City of Bloomington Common Council

Ordinance 21-07 – To Amend the City of Bloomington Zoning Maps by Amending the District Ordinance and Preliminary Plan for Parcel E of the Thomson PUD – Re: 300 W. Hillside Drive (Tom Brennan, Petitioner)

To: Members of the Common Council
From: Eric Greulich, Senior Zoning Planner
Subject: PUD-17-20
Date: January 19, 2021

Subject: PUD-17-20: W. Hillside Warehouse redevelopment, third hearing
300 West Hillside Drive, Tract E of Thomson PUD

BUILDINGS 3-6 PROPOSED ELEVATIONS

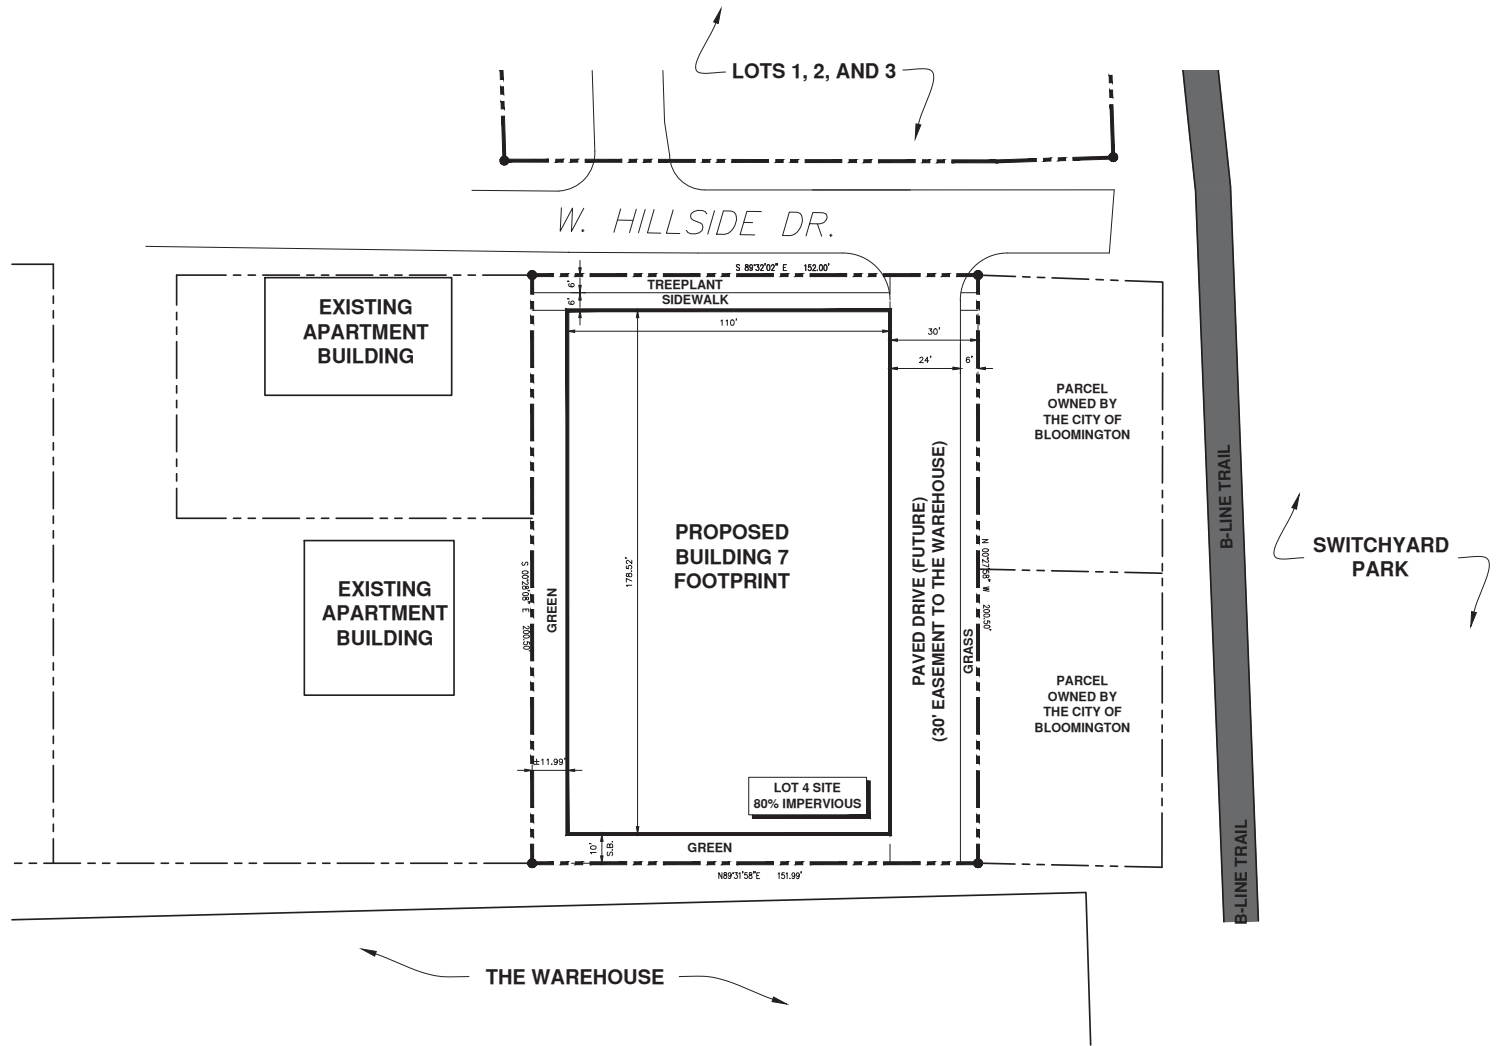
1. The proposed buildings in the Final Plan must be consistent with the currently submitted elevations including orientation, modulation, and materials. The west elevations of all building must be similar to the design of the east elevations as presented.
